Machine	TASKI ergodisc
Subassembly	Dispensing unit electrical

New, more efficient pump for the electrical dispensing unit ergodisc

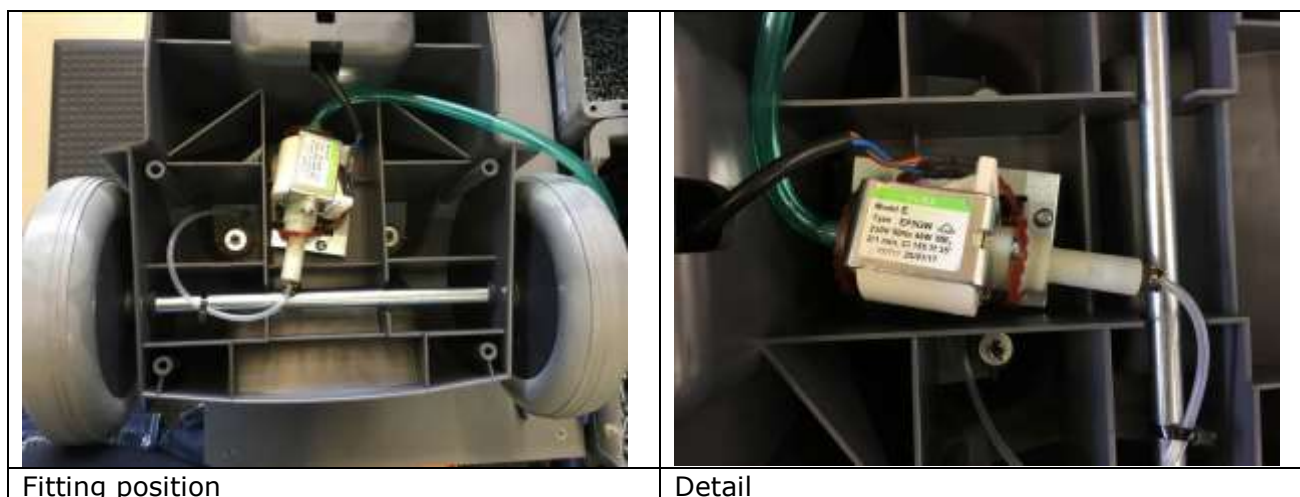
Recurring problems in the field with the pump of the electrical dispensing unit in interaction with the product Jontec spray have led us to introduce a new pump. This one has about 30% more power and accordingly a higher operating pressure.

Prior tests have shown that with this new pump a better spraying result with less dripping can be reached.

The pump is backwards compatible and can simply be affixed to the existing bracket. But as the anti-rotation protection cannot be mounted, the pump is no longer secured against twisting, but it doesn't matter in this case.

The two pumps can be distinguished from each other by the color (old: blue, new: white)

Description	Material number	Remarks
Pump 230V 50Hz 48W	4132663 (4630/010)	New spare part number
Pump 230V 50Hz 32W kpl.	4110140 (4630/006)	Existing spare part number
